TYPICAL SECTION

LILIHA STREET REHABILITATION
North King Street to School Street
Project No. 7413A-01-04M

"AS-BUILT"

C.O. ADD. 7

SHEET No. 1 OF 4 SHEETS

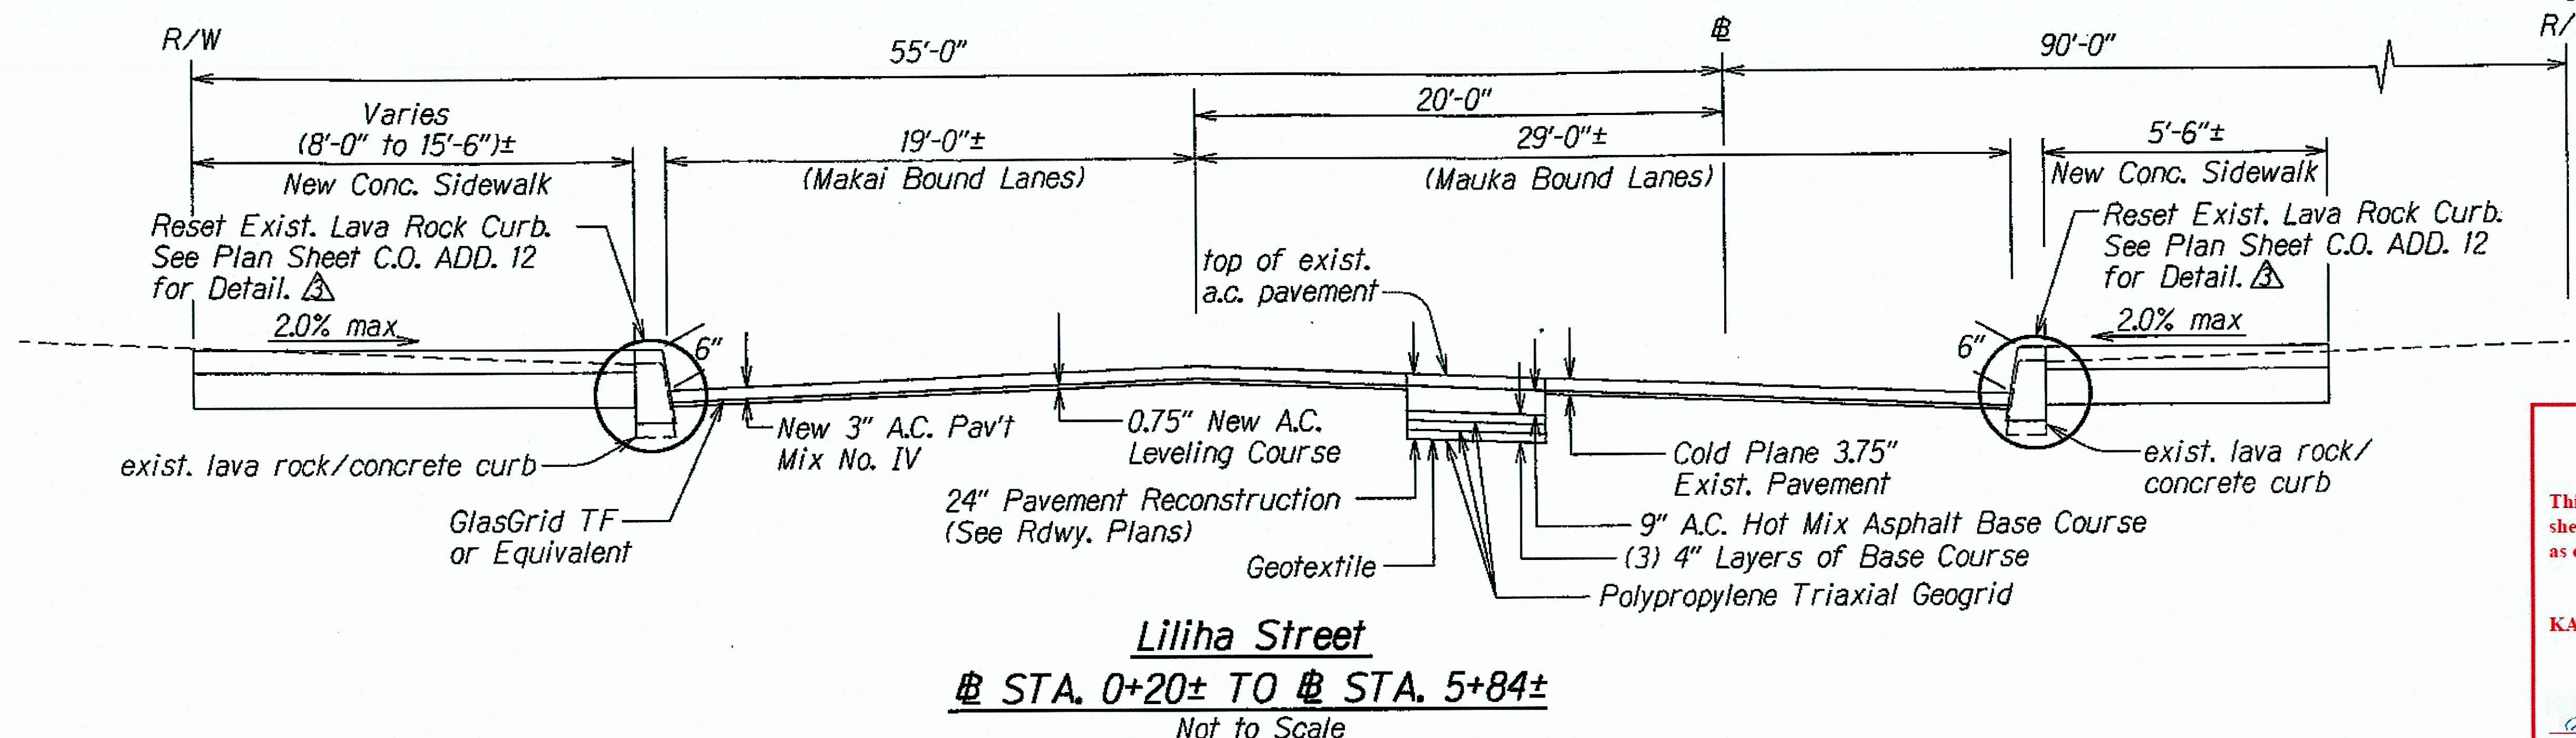
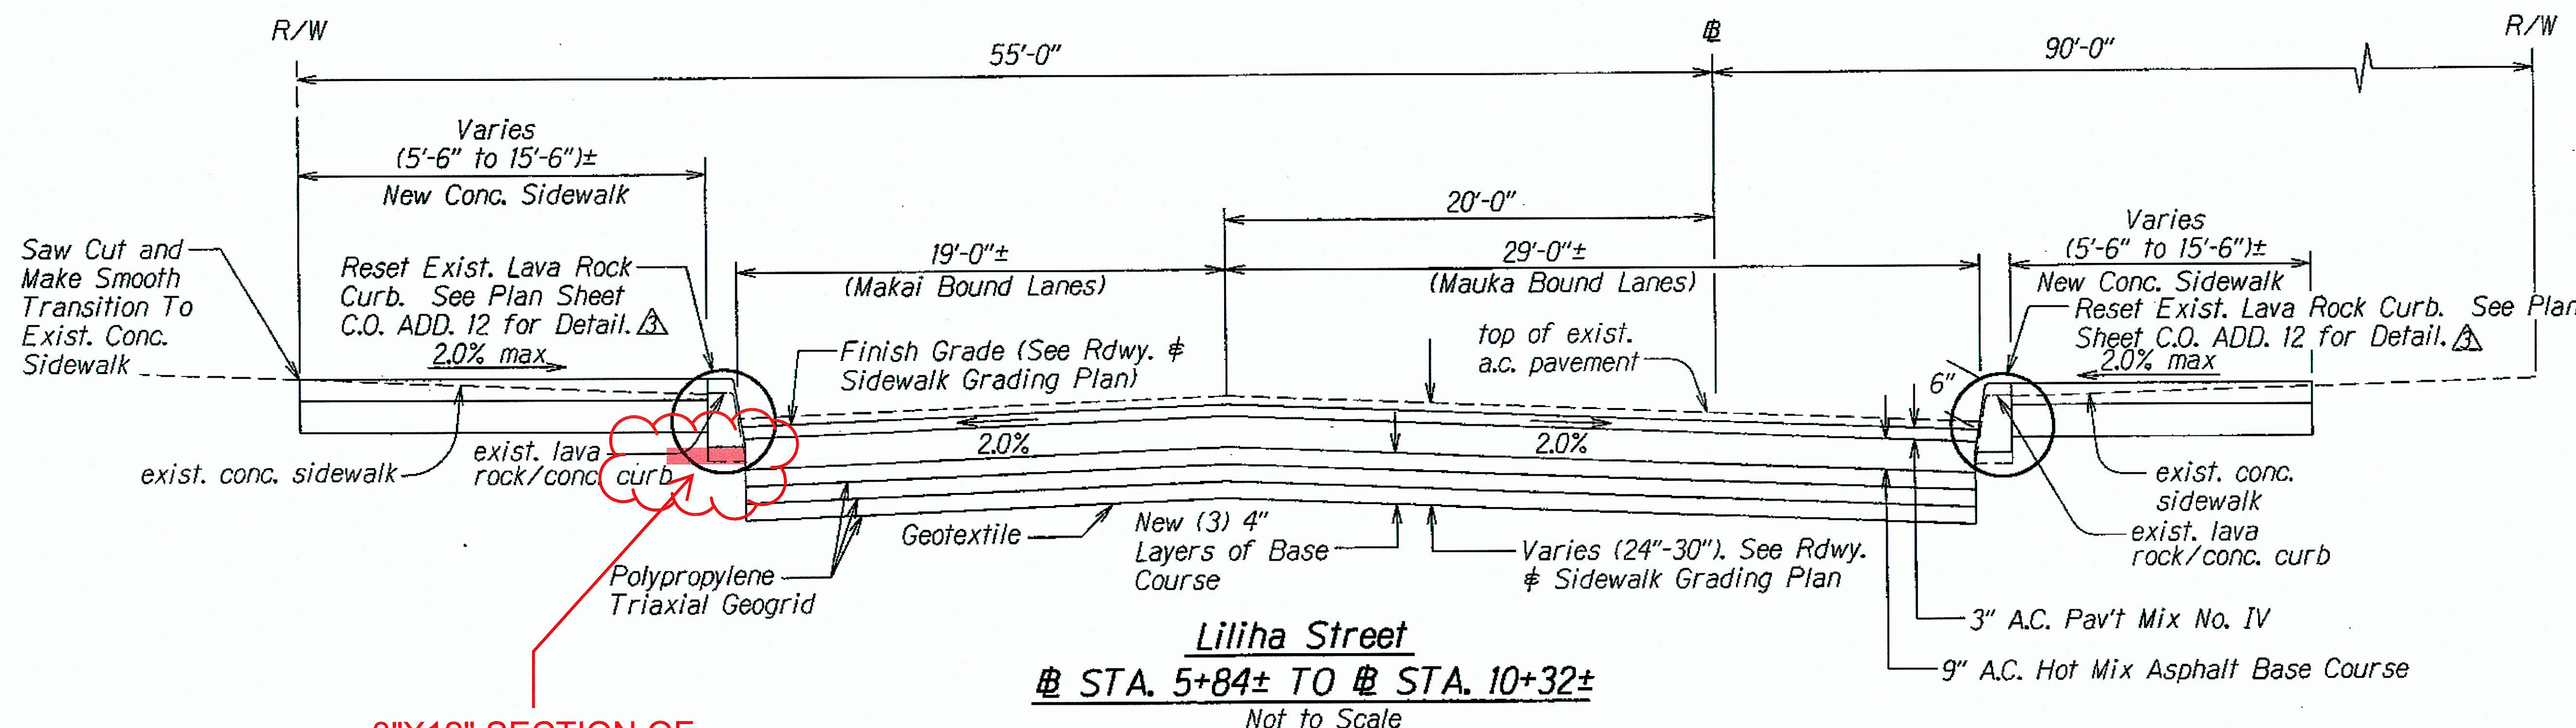
8/20/15	Revised Typical Sections and Added Resetting of Lava Rock Curb Detail Inset.
6/16/14	Corrected Typical Section.
DATE	REVISION

1. Reconstruction pavement installation procedures:

- Excavate to the subgrade elevation. Will involve the removal of concrete slab.
- Proof-roll the subgrade to a smooth surface. If the ground is very soft, HWY-LG should be informed to provide additional recommendations.
- Place non-woven geotextile (Spec 716.06)
- Place the polypropylene (punched and drawn) triaxial geogrid (Tensar TX7 or equivalent).
- Place and compact 4" thickness of base course (with nominal maximum particle size of 3/4") to a minimum of 90 percent of its maximum dry density as determined by AASHTO T180.

- Place the polypropylene (punched and drawn) triaxial geogrid (Tensar TX7 or equivalent).
- Place and compact 4" thickness of base course (with nominal maximum particle size of 3/4") to a minimum of 90 percent of its maximum dry density as determined by AASHTO T180.
- Place the polypropylene (punched and drawn) triaxial geogrid (Tensar TX7 or equivalent).
- Place and compact 4" thickness of base course (with nominal maximum particle size of 3/4") to a minimum of 95 percent of its maximum dry density as determined by AASHTO T180.
- Place and compact the 12" AC+ACB layers.

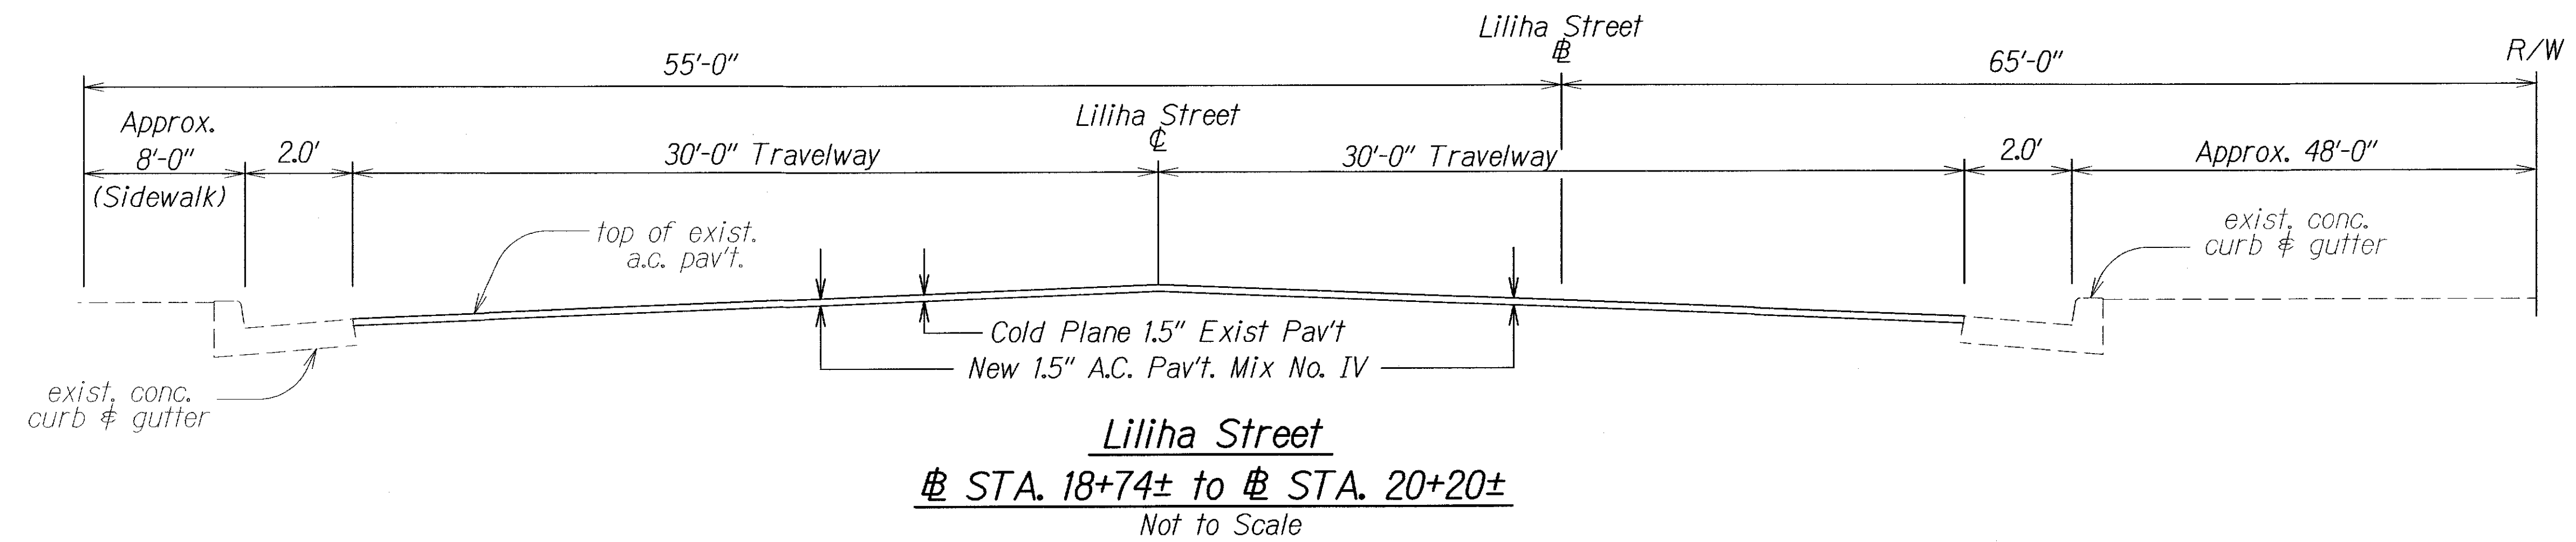
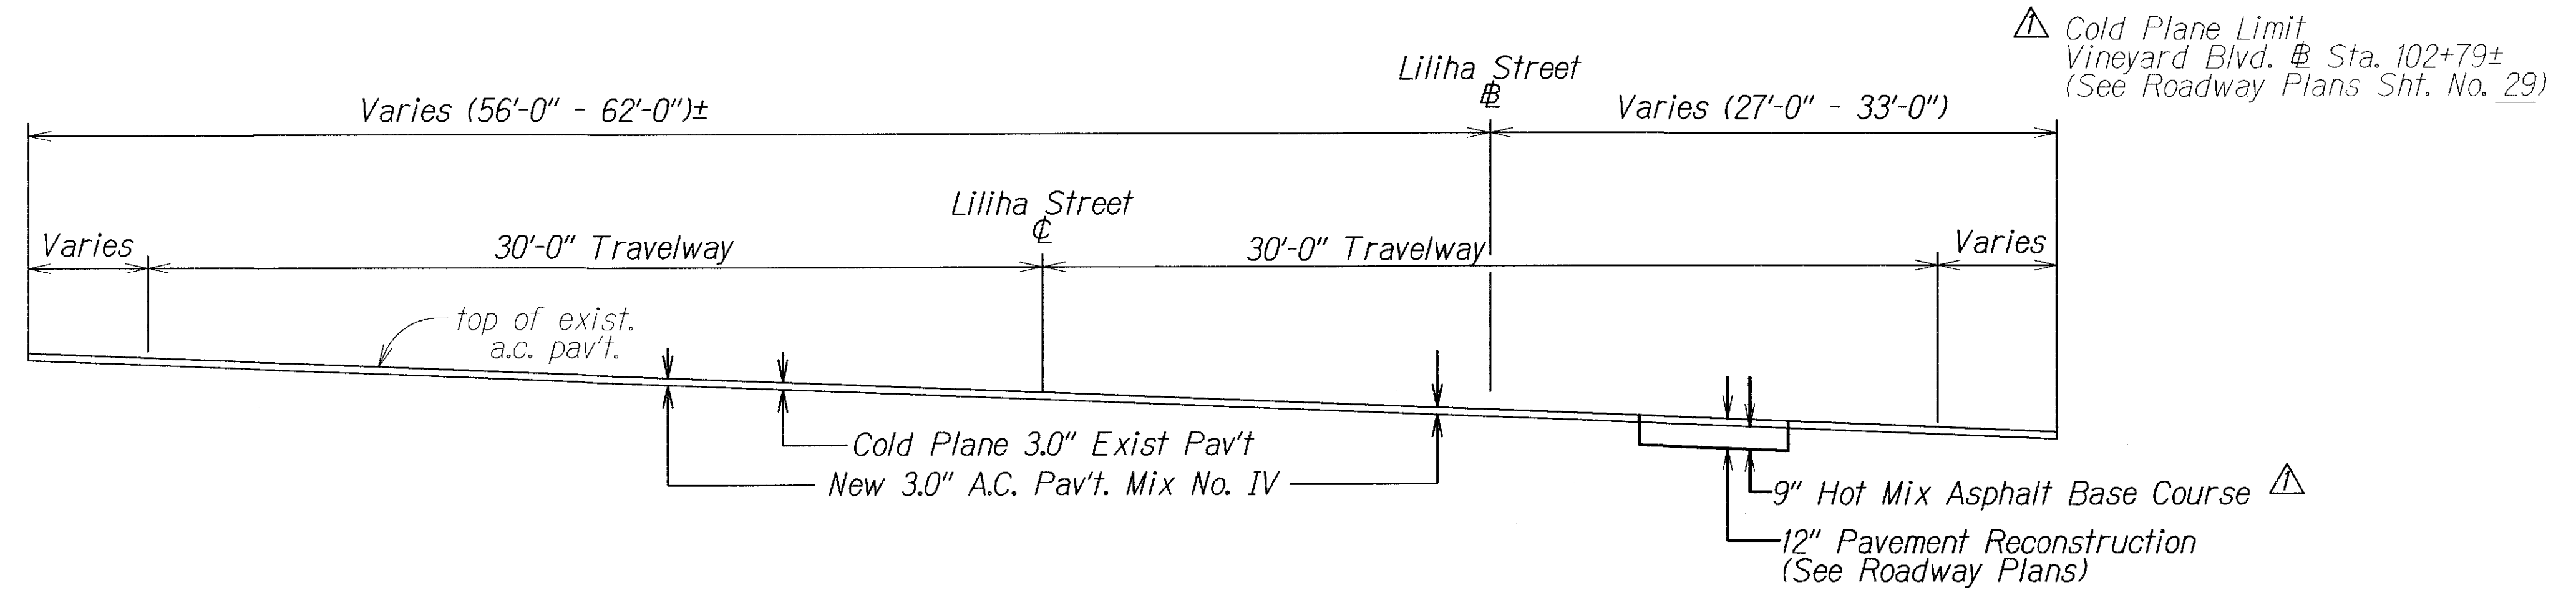
△ Cold Plane Limit
Vineyard Blvd. @ Sta. 101+90±
(See Roadway Plans Sht. No. 29)
